Initial Project Review

Preliminary Plat: Summer View Townhouses

Application Numbers: 1000212,1001294

Preliminary Plat Map

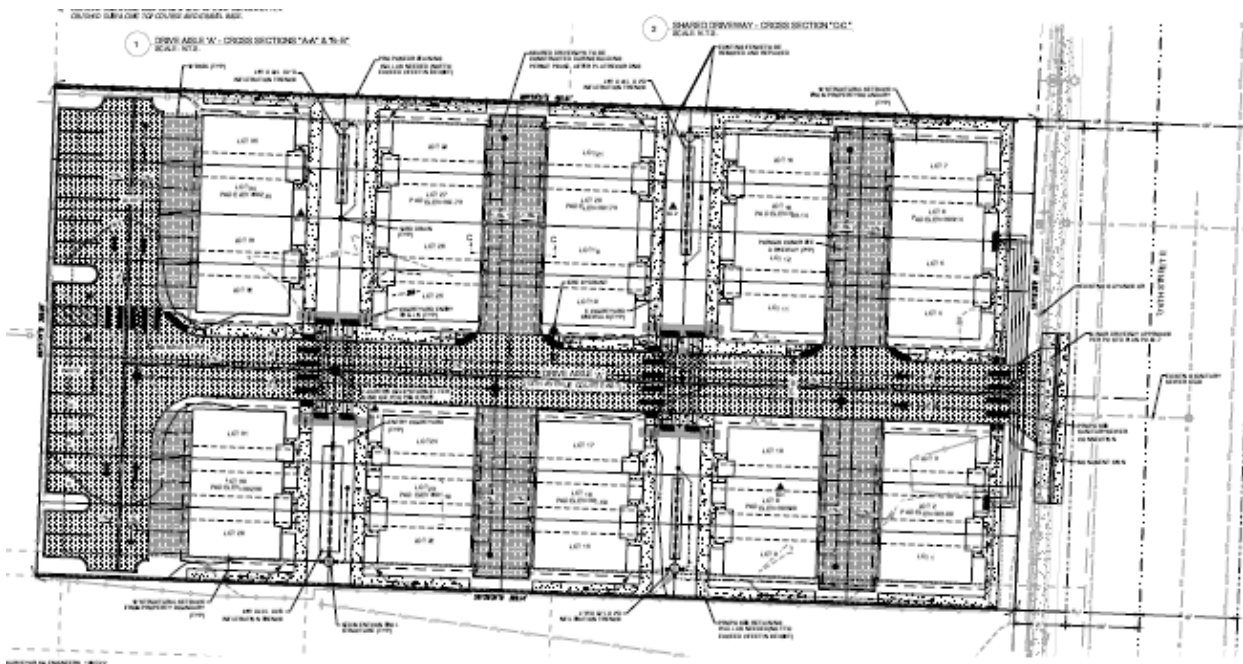
Staff Comment: The maintenance easements are shown on the face of the plat. It will be required to be shown on the Final Plat.

Staff Comment: The applicant is meeting the off-street parking by placing the parking areas behind the proposed homes. Pedestrian connectivity has been made but shall not be painted. A change will be required to adhere to the code. Bicycle facilities are not required. Any transit stop requested will need to be approved by the traffic section of Planning and Public Works (PPW).

Staff Comment: The applicant will need to address lighting of the pedestrian ways along with drive aisles.

Landscape Plan (February 15, 2023)

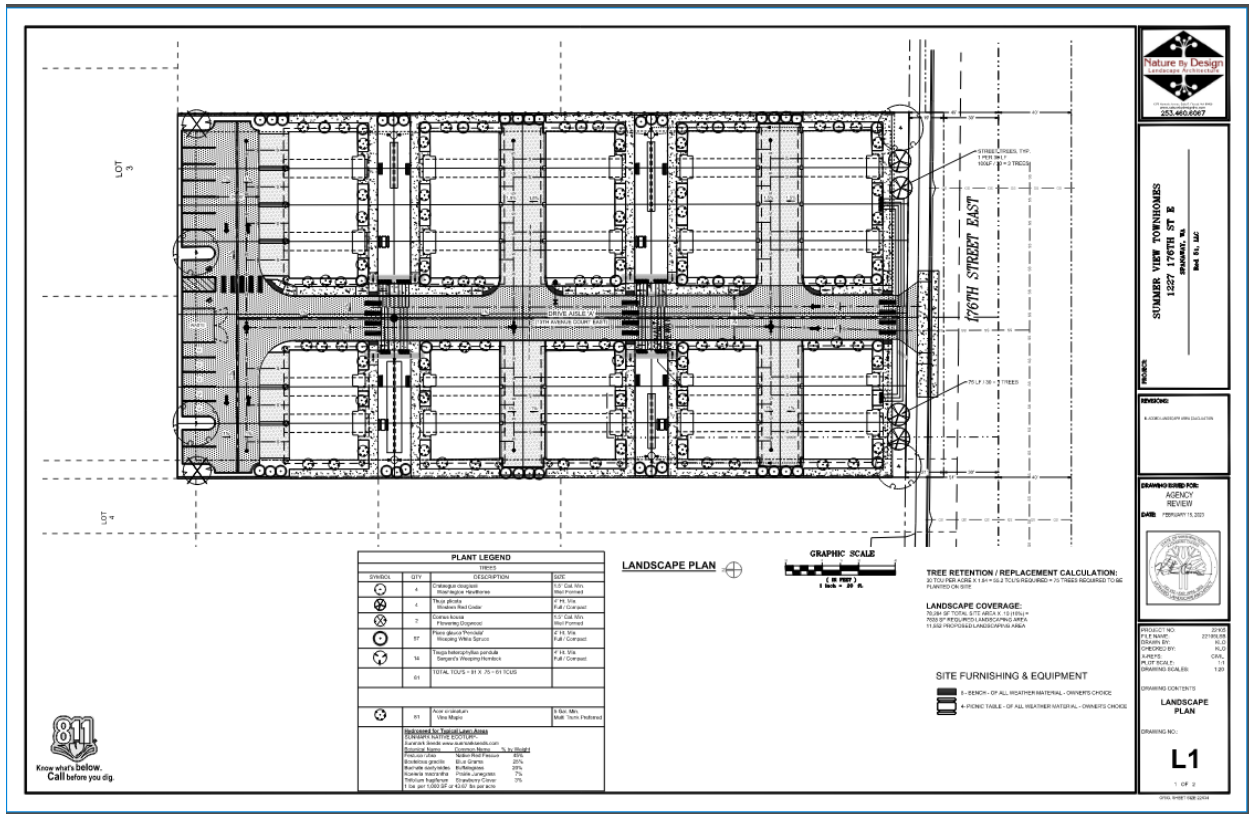
Staff Comment: The tree conservation code requires that 55 tree units be met for the 1.84-acre site (30 trees per acre x 1.84 acres). The applicant has proposed 81 tree units on the landscape plan. This requirement has been met.

Staff Comment: This requirement has been met with the landscape plan, dated February 15, 2023.
